Model	Fiery XJ Series (XJ170R)	Volt/Hz	Date of Modification	Serial Number
Modified Article	Parts Catalog			
Reason for Modification	Parts Catalog Correction

Model	Fiery XJ Series	Volt/Hz	Date of Modification	Serial Number
Modified Article				
Reason for Modification	System software upgrade

Model: Fiery XJ Series(XJ80e only)		Date: 31-Mar-97	No: 7
Modified Article: Parts Catalog		Prepared by: N.Kaiya	
From: QAC 1st Field Information Dept.		Checked by: T. Inoue <i>T. Inoue</i>	
Reason for Modification:	<input checked="" type="checkbox"/> Parts catalog correction	<input type="checkbox"/> Vendor change	<input type="checkbox"/> To meet standards
	<input type="checkbox"/> To facilitate assembly	<input type="checkbox"/> To improve reliability	()
	<input type="checkbox"/> Part standardization	<input type="checkbox"/> Other

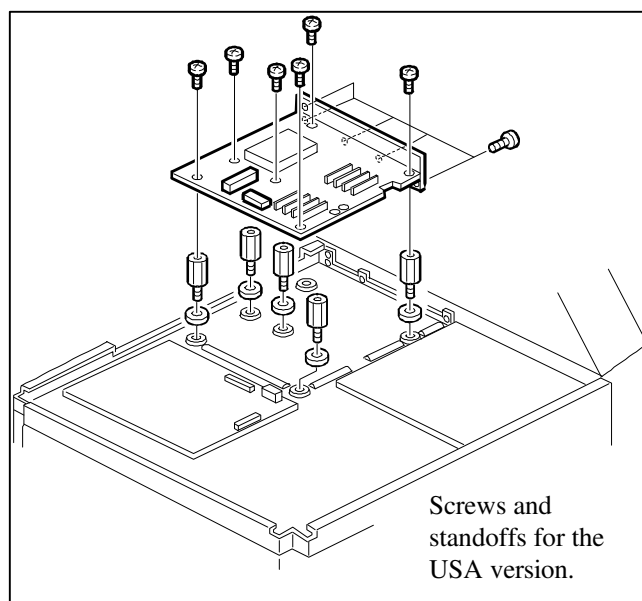
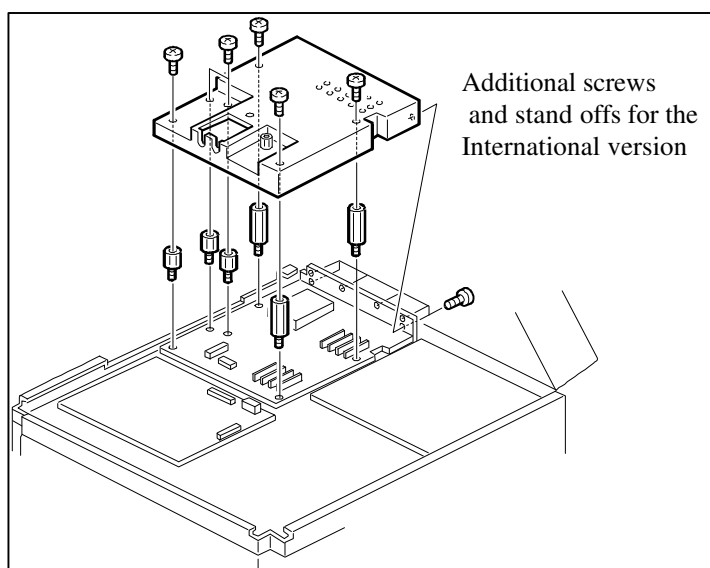
The screws and standoffs are different between the USA version model (-43) and the International version model (-44). This is because the International version requires installation of the EXU Shield Cover.

For the Disk Pack, part numbers have been separately assigned for the Mac Disk Pack and the Windows Disk Pack.

Also, please correct the index numbers in the illustration in your parts catalog. Please exchange index no.8 and index no.9.

Old part number	New part number	Description	Qty	Int	Destination	Page	Index
A7245356	A7245398	Screws and Standoffs:10007781	1-1		-43	3	4
A7245356	A7245399	Screws and Standoffs:10007782	1-1		-44	3	4
A7245364		Disk Pack - English	1-		-43,-44	3	9
	A7245376	Mac Disk Pack English:10011587	-1		-43,-44	3	9
	A7245377	Windows Disk Pack English:10011588	-1		-43,-44	3	9
